**AUTHORITY:** CITY OF PUYALLUP

**OCCUPANCY:** B, MEDICAL OFFICE BUILDING

SHEET TITLE:  
**PROJECT INFO /  
INDEX / SITE  
PLAN**

SHEET TITLE:  
**THIRD FLOOR  
PLUMBING PLAN**

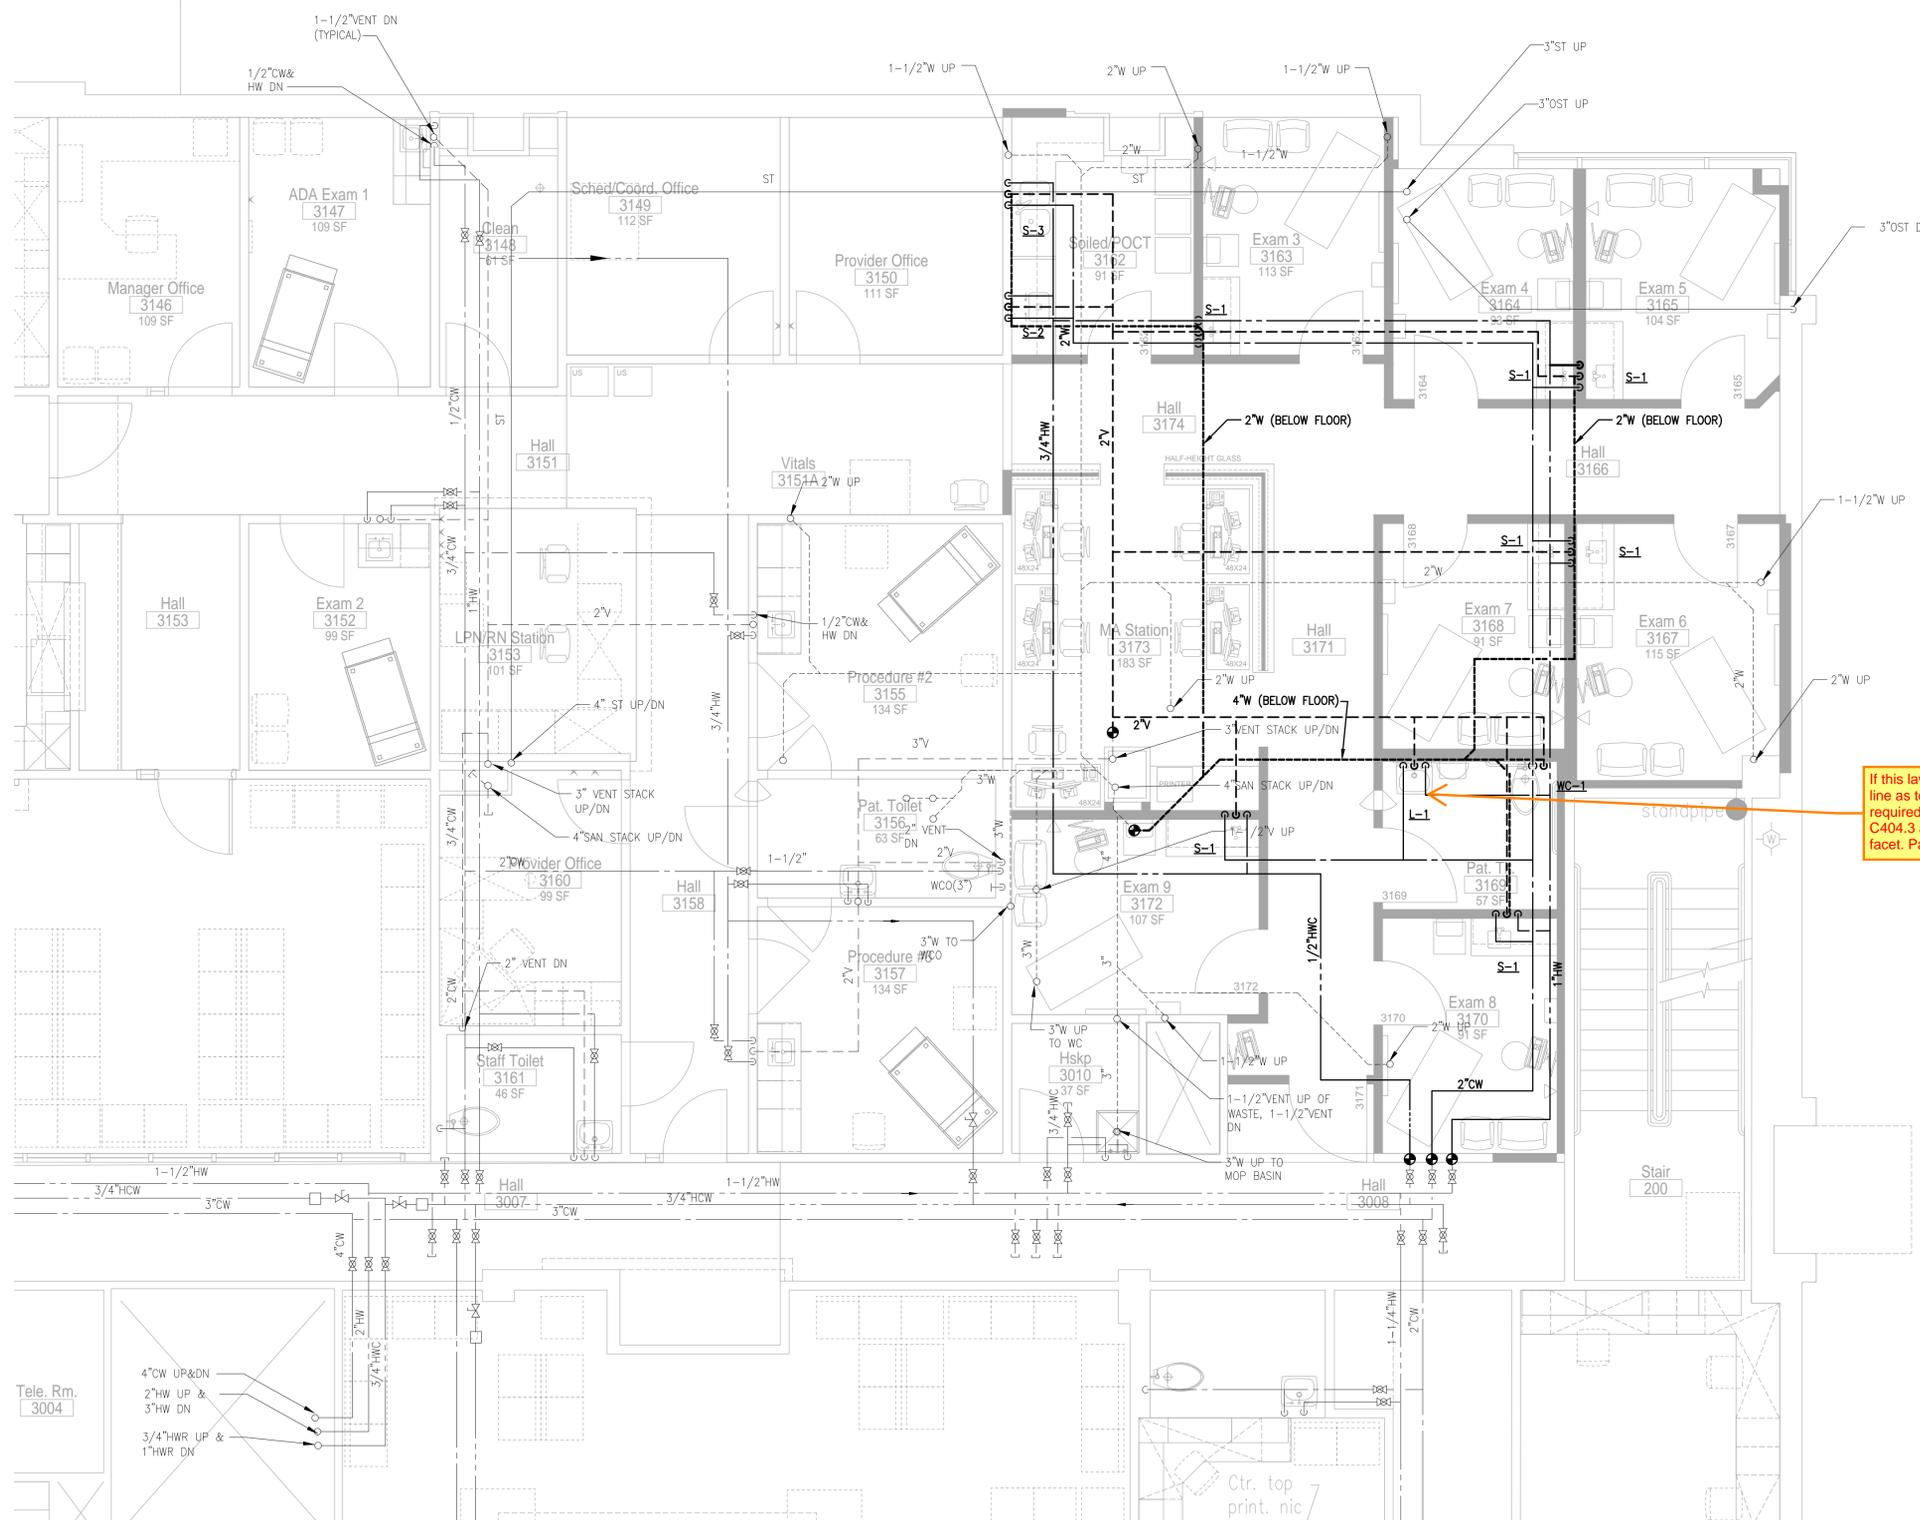
If this lav is not served by a recirculating hot water line as told by applicant then a insta-hot would be required for compliance with the 2018 WSEC section C404.3 and table C404.3.1 as this is a public lavatory facet. Page P1.2 of plans.
